Modification and partial demolition of existing buildings and construction of a six (6) storey mixed-use building comprising ground floor shop, offices on levels three (3) to five (5) and associated car parking from ground to level two (2).

85-87 Jetty Road, Glenelg

DA 110/M001/19

Application No	110/M001/19
Unique ID/KNET ID	2019/04287 (Knet No.14710696)
Applicant	Taplin Group
Proposal	Modification and partial demolition of existing buildings and construction of a six (6) storey mixed-use building comprising ground floor shop, offices on levels three (3) to five (5) and associated car parking from ground to level two (2)
Subject Land	85-87 Jetty Road, Glenelg
Zone/Policy Area	District Centre Zone – Glenelg Policy Area 2
Relevant Authority	State Commission Assessment Panel
Lodgement Date	23 December 2016
Council	Holdfast Bay Council
Development Plan	Holdfast Bay Council consolidated 2 June 2016
Type of Development	Consent on Merit
Public Notification	Category 2
Representations	One (1) representor, wishing to be heard
Referral Agencies	Government Architect
Report Author	Ben Scholes, Senior Planning Officer
RECOMMENDATION	Development Plan Consent subject to conditions

Figure 6-3: Approximate separation from nearest areas of residential private open space

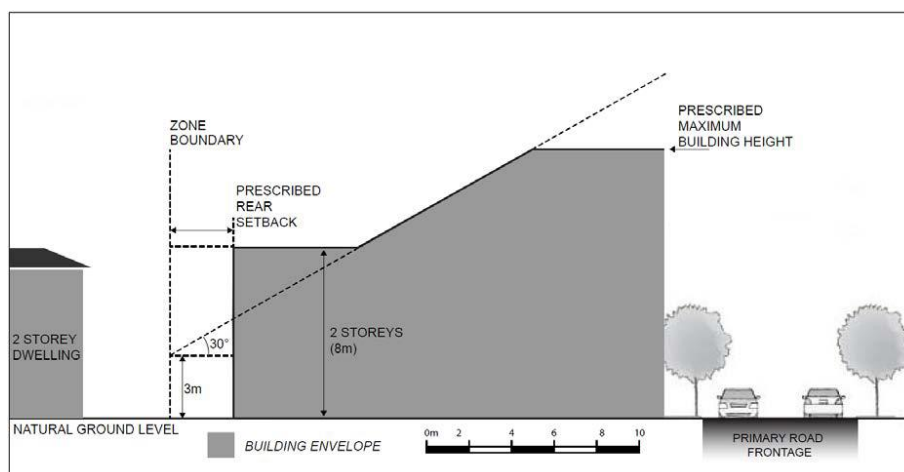
In response to the representor's concerns, the applicant maintains the likely impacts on residential amenity available to residences located further to the north are expected to be minimal (as shown in Figure 6) and would be well within the scope of interface conditions expected in PDC 8, justifying the applicant's preference for dispensation of the building envelope provision.

The potential for impacts on future residential development at 2 Byron Street, Glenelg are hypothetical at this stage and it would not be reasonable for that scenario to provide the basis of assessing (or objecting to) the merit of this application. As such, the development proposal does not raise legitimate concerns related to residential amenity impacts likely to be caused by expected interface conditions.

Figure 1: Approximate separation from nearest areas of residential private open space

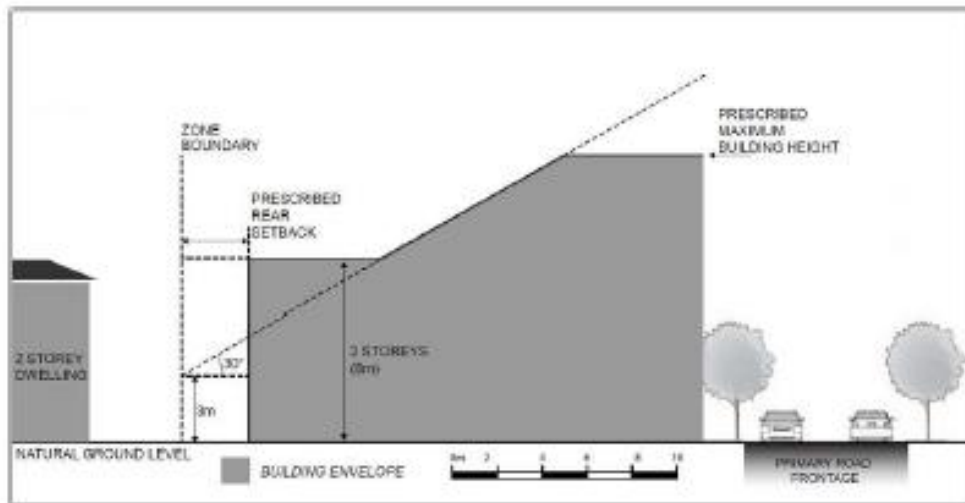
The proposed building breaches a 30-degree plane extending from the site's northern boundary however PDC 8 expressly allows such a breach to occur where "the proposed development minimises interface impacts including from building massing, overshadowing and overlooking with adjoining residential development".

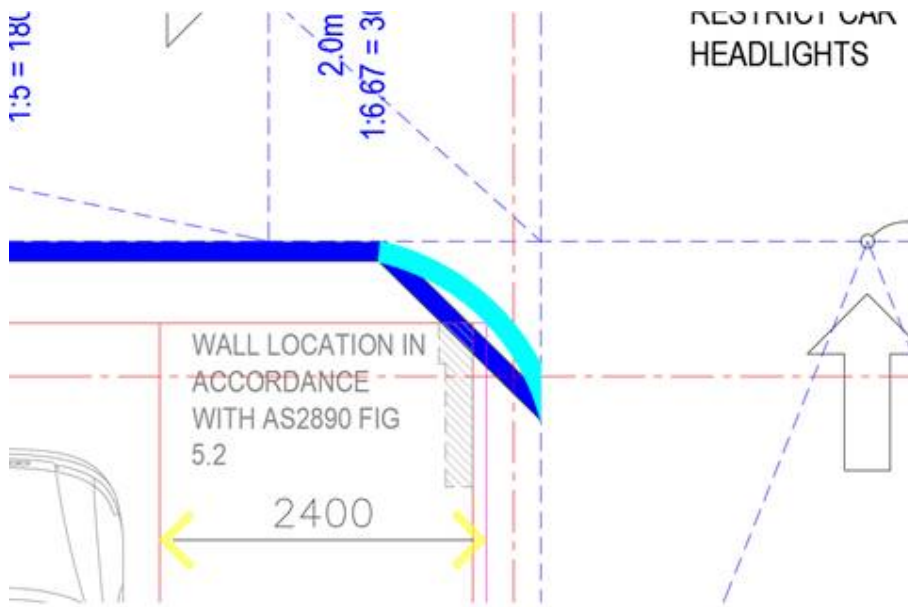
The image below shows that if the corner space widths were widened to 2.4m (yellow), the vehicle clearance envelope (green) would protrude only slightly over the wall (blue). This could potentially be overcome by minor rounding of this corner wall instead of the angle edge shown above.

On the above basis the designated number of small spaces would reduce to 9 spaces. Consequently, the proportion of small car parking spaces would then reduce to approximately 19% of the total spaces and would be consistent with the number of small cars based on the 2019 car sales data.
